DEVELOPMENT REVIEW COMMITTEE (DRC) COMMENT REPORT

PROJECT NAME: Selo Hotel Condo

CASE NUMBER: UDP-S20004

REQUEST: Site Plan Level II Review: 150 Residential Units, 200 Hotel Rooms, 11,835 Square Feet of Retail and Restaurant Use, and 2,785 Square Feet Rooftop Bar in Downtown Regional Activity Center

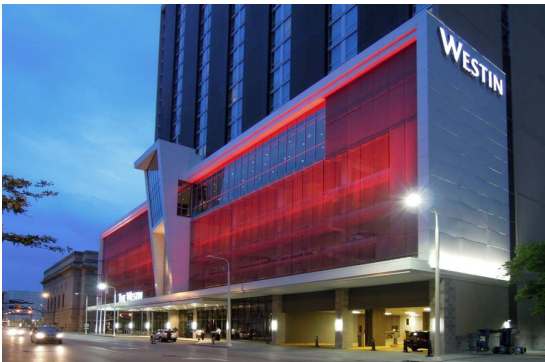
13. The proposed screening material for the parking podium does not provide adequate screening and is not exceptional in design as required in the DMP. Glazing does not screen vehicle headlights. In addition, the exposed stairwell should be redesigned and enclosed. The following images are being provided as examples.
